Model: PRIPORT TITANIUM		Date: 7-Apr-03	No: R-C252-001
Subject: Notes the model TT installation		Prepared by: M. Ohtsubo, Priport Service Planning Section	
Classification:	<input type="checkbox"/> Troubleshooting <input type="checkbox"/> Mechanical <input type="checkbox"/> Paper path <input type="checkbox"/> Other ()	<input type="checkbox"/> Part information <input type="checkbox"/> Electrical <input type="checkbox"/> Transmit/receive	<input type="checkbox"/> Action required <input checked="" type="checkbox"/> Service manual revision <input type="checkbox"/> Retrofit information
Model Name: Ricoh JP730/JP750/JP780C, Gestetner 6123lcp/5410c/6123cp, Lanier LDD 730, nashuatec 6123cp, RexRotary 6123cp

Model: PRIPORT TITANIUM		Date: 23-Oct-03	No: R-C252-003
Subject: Notes for model TT installation - revision		Prepared by: M. Ohtsubo, Priport Service Planning Section	
Classification:	<input type="checkbox"/> Troubleshooting <input type="checkbox"/> Mechanical <input type="checkbox"/> Paper path <input type="checkbox"/> Other ()	<input type="checkbox"/> Part information <input type="checkbox"/> Electrical <input type="checkbox"/> Transmit/receive	<input type="checkbox"/> Action required

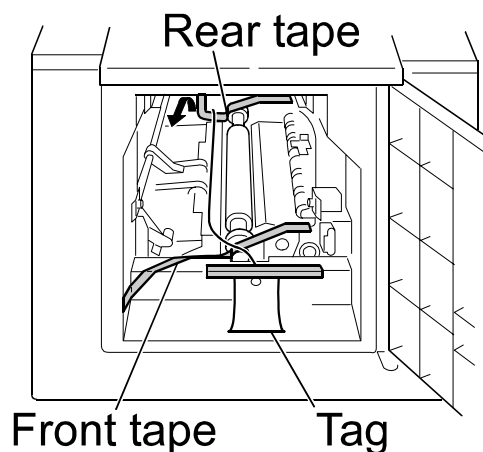
Strips of tape have been added as shown below to secure the Press Roller during transport. Please make sure to remove the tape and tag before machine operation begins. If they are not removed:

- Paper jams or blank images may occur, due to the lack of pressure on the Press Roller.
- The tape may stick to the drum screen or Press Roller.

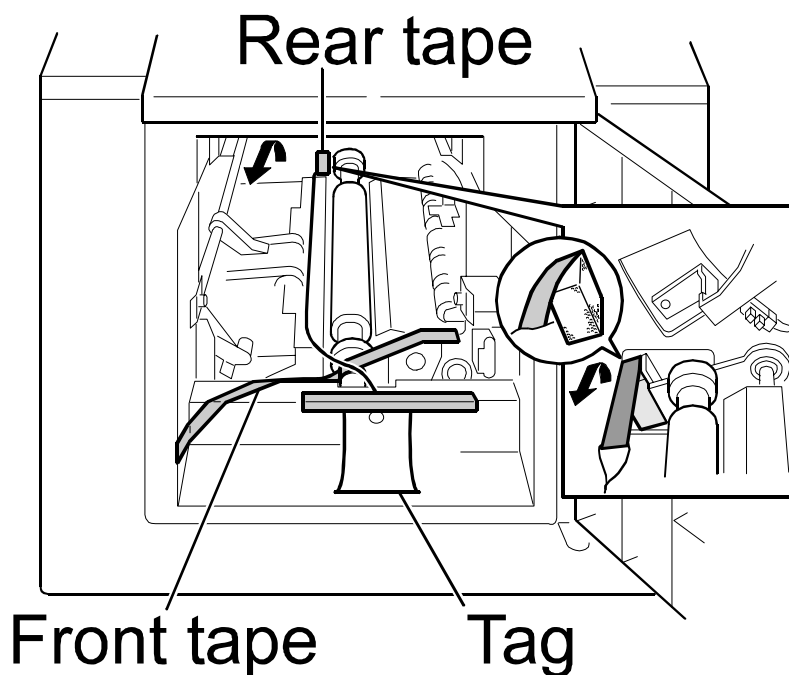
As announced in RTB #RC252-001, a Styrene foam sponge is used to ensure that the rear shipping tape stays properly fixed in place, which prevents the printing pressure release lever from unlocking. At installation, please remove the rear tape by pulling the portion shown in the photo below toward the front of the machine.

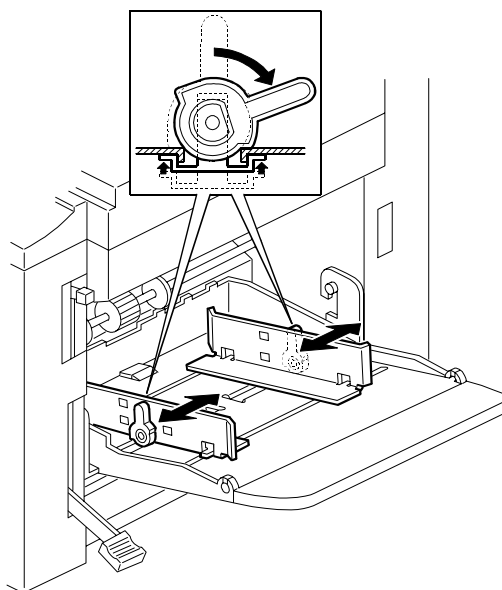
The left or/and right edges of the original can be seen on the printout as black lines.

1. The paper tray side fences are not aligned with the scanner unit side fences.

2. The original is smaller than the printing paper.

1. Measure the distance from the paper edge to the black line (X mm).
2. Move the side fences a distance of about X mm, so that the edge of the paper aligns with the edge of the original.
3. Check the print results. Repeat this until you cannot see the black line on the printout.

1. Decrease the image density setting, or
2. Increase the magnification setting so that the original size matches the print paper size.

1.2.4 PRINTER UNIT VC-20 (OPTION)

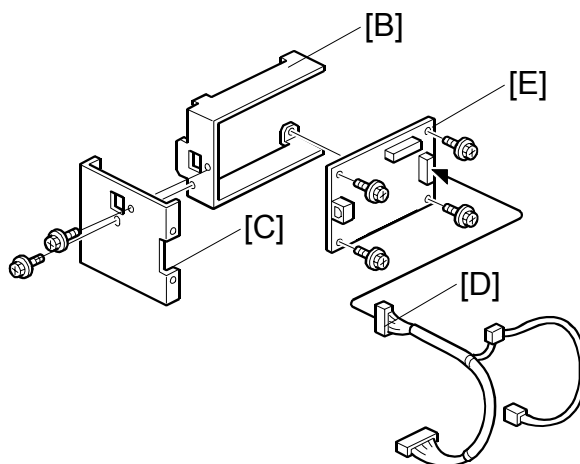
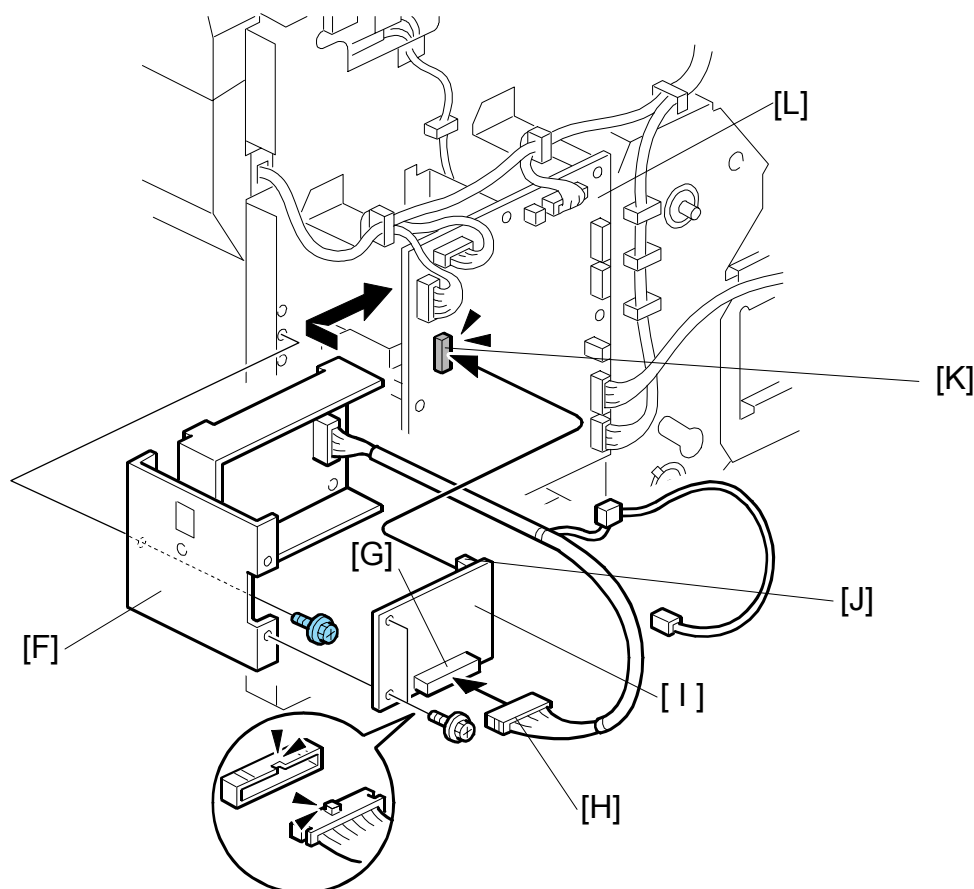
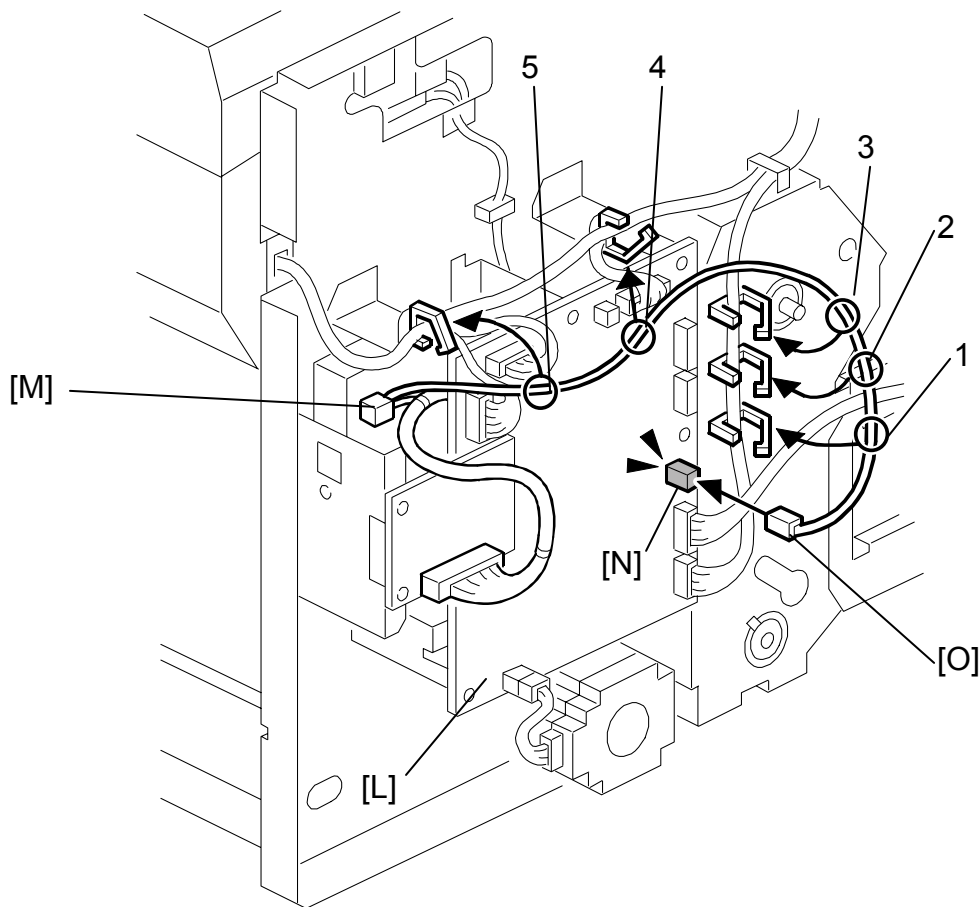
1. **Add** the interface board type 20 to the Installation Procedure (sec 1.2.4).

1. Remove the bracket [A] (⌀x1).

2. Attach the printer controller board [E] to the bracket [B] (⌀x4).
3. Attach the bracket [C] to the bracket [B] (⌀x2).
4. Connect the connector [D] to the socket on the right side of the board [E].
NOTE: Make sure that the connector is securely connected to the socket.

5. Attach the bracket assembly [F] to the same place that the bracket [A] (Step 1) was installed (1 screw).

7. Connect the connector [H] to the socket [G] on the interface board.
8. Attach the interface board [I] to the bracket assembly [F] (⚙ x 2).

9. Connect the connector [O] to CN102 on the MPU [N].

10. Clamp the harness to the five places shown (#1-5) around the MPU [L] (🔧x5).
